SERVICE INSTRUCTIONS

SUBJECT: FORD TRUCK DO NOT REUSE CONN ROD BOLTS

INTRODUCTION

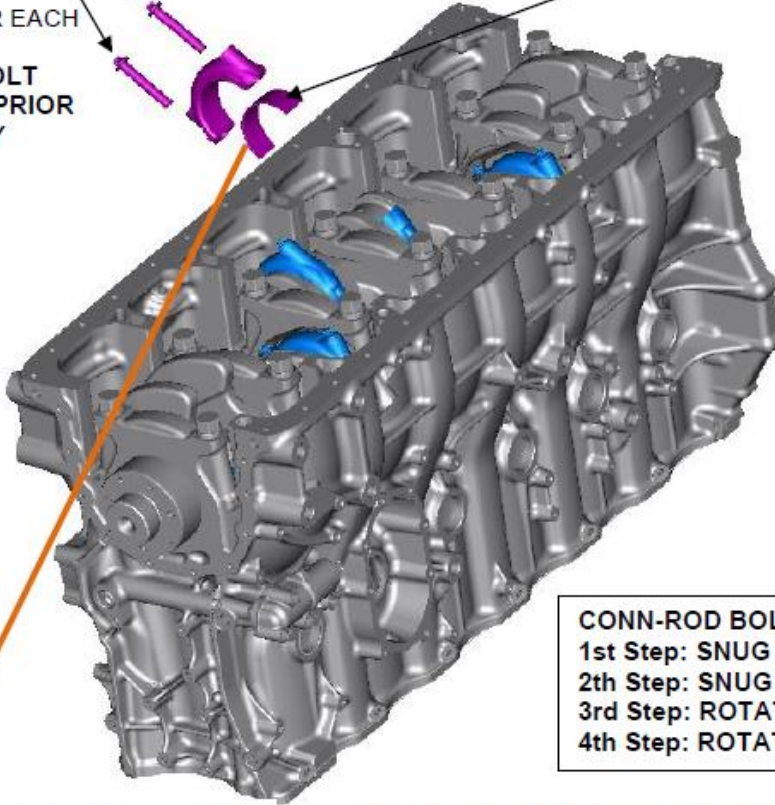
The Ecotorq Gen 1.5 conn rod bolts are unable to reuse.

The Gen 1.5 conn rod bolts are tightened over the yield strength. The bolts can withstand three tightening procedures. The serial production of the engines at the plant requires 3 tightening procedures due to general checks and end of line tests. Therefore, first bolts on the engine are not reusable. If the bolts are changed in service, the bolt can be used for 2 more servicing procedures totally adding up to the limit, 3 tightening.

GC46-6215-A
BOLT- CONN ROD
M13x1.5x79
(2 PLACES FOR EACH
CYLINDER)
CONN ROD BOLT
TO BE OILED PRIOR
TO ASSEMBLY

NC46-6213-A
BEARING CONN ROD LOWER
(1 PLACE FOR EACH
CYLINDER)

CONN-ROD BOLTS TIGHTENING STRATEGY:
1st Step: SNUG TORQUE 30 Nm
2th Step: SNUG TORQUE 60 Nm
3rd Step: ROTATE 90°
4th Step: ROTATE 70°

MAKE SURE THAT THE FORD LOGO ON THE LOWER CONROD BEARING IS AT THE SIDE WITH FRONT MARK BOSS AT ASSEMBLY.

CHECK THAT **THERE IS VISIBLE BLACK MARKING** ON THE EDGE OF THE BEARING TO BE ASSEMBLED TO THE **CAP SIDE**
